REQUEST FOR BID
#14-0080
TB RAMP AND STAIRS

ADDENDUM #2

Please find below the answers to questions received for Sedgwick County project 14-0080, TB Entrance Ramp and Stairs.

SHEET TITLE: ADDENDUM #2 -
REVISIONS TO RAINLEADER

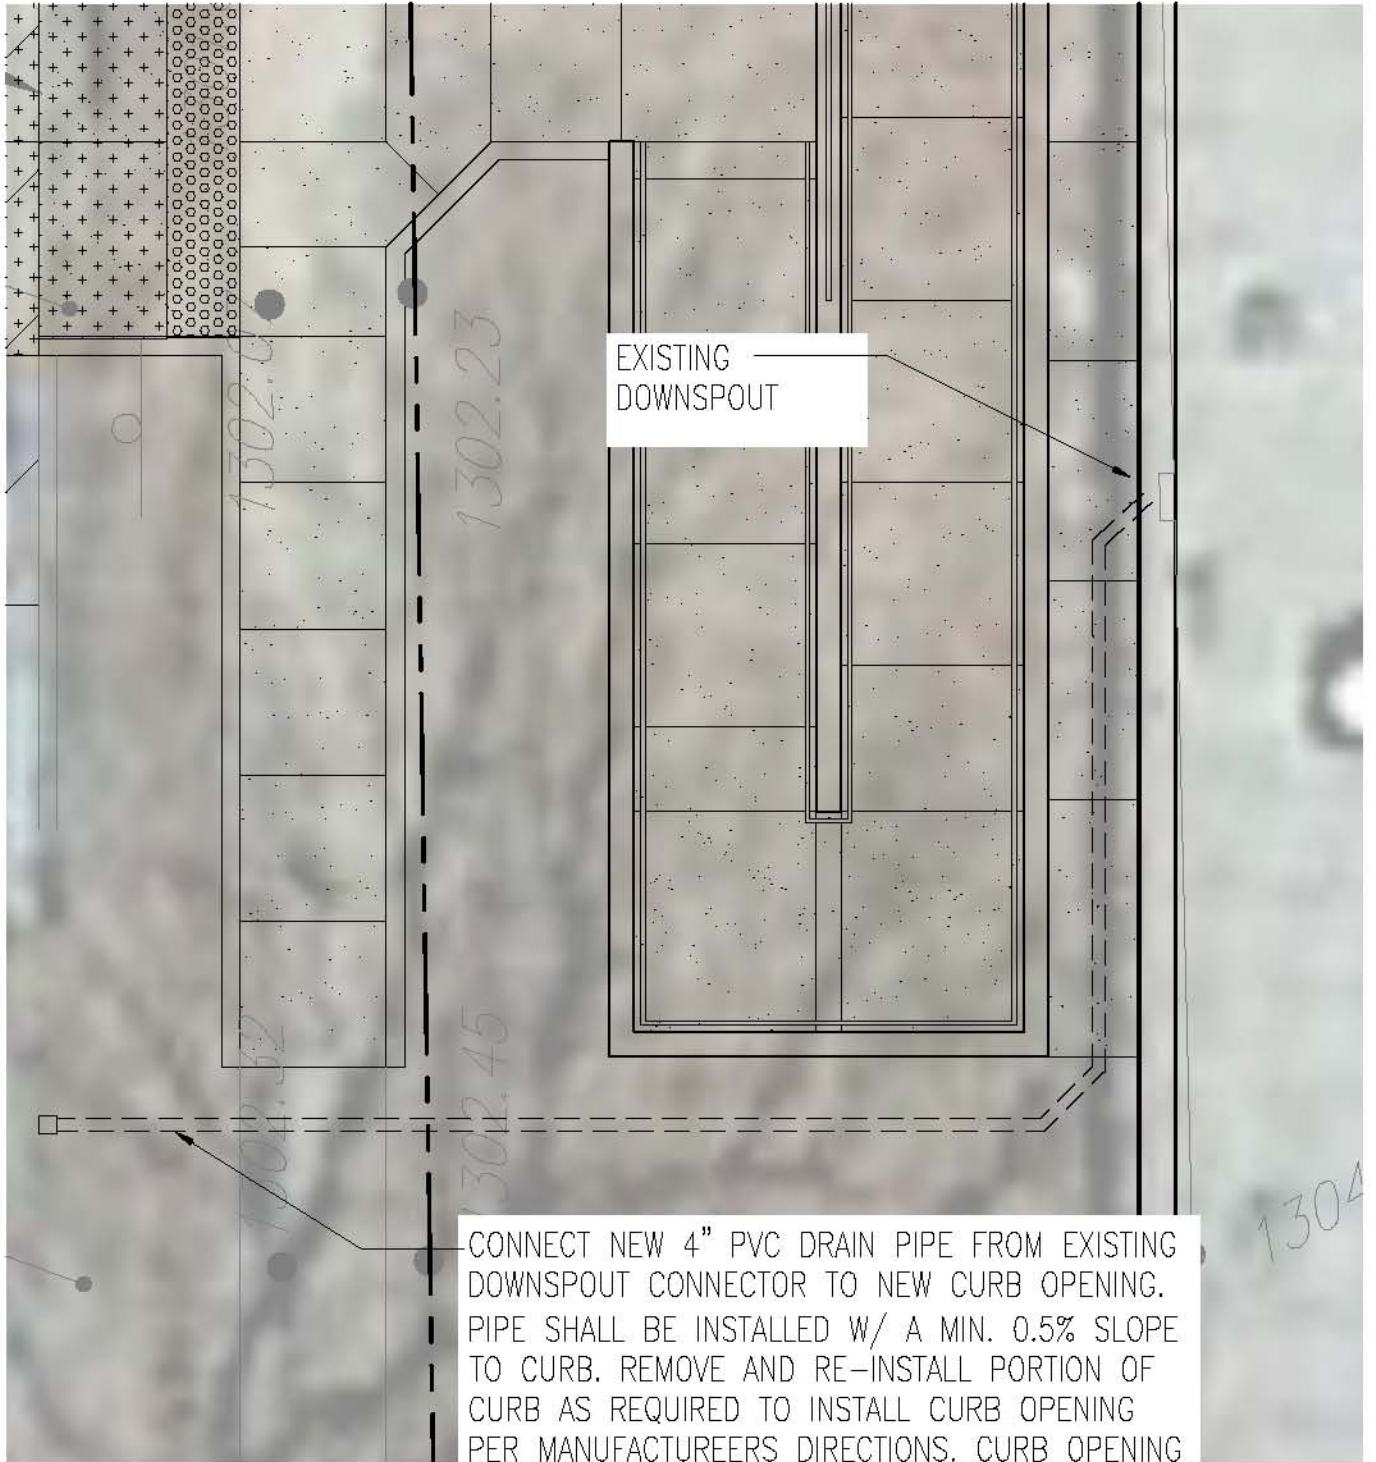
- Q1. If this entrance is to be ADA accessible, dose the door need to have an automatic opener installed on it?**
A1. *No, an automatic door opener is not required for an ADA compliant entrance.*
- Q2. Reference revised plan sheet SP2.0. There appears to be a conflict with the new ramped sidewalk and the new rain leader drain line. Is the elevation of the new ramped sidewalk too low for the new rain leader drain line to cross underneath it as shown?**
A2. *There is an elevation conflict between the drain line and sidewalk, see attached cut sheet for new route of rain leader drain line.*

CONNECT NEW 4" PVC DRAIN PIPE FROM EXISTING DOWNSPOUT CONNECTOR TO NEW CURB OPENING. PIPE SHALL BE INSTALLED W/ A MIN. 0.5% SLOPE TO CURB. REMOVE AND RE-INSTALL PORTION OF CURB AS REQUIRED TO INSTALL CURB OPENING PER MANUFACTUREERS DIRECTIONS. CURB OPENING SHALL BE A NEENAH FOUNDRY R-3262 SERIES STORM WATER OPENING W/ 4" PIPE CONNECTOR.
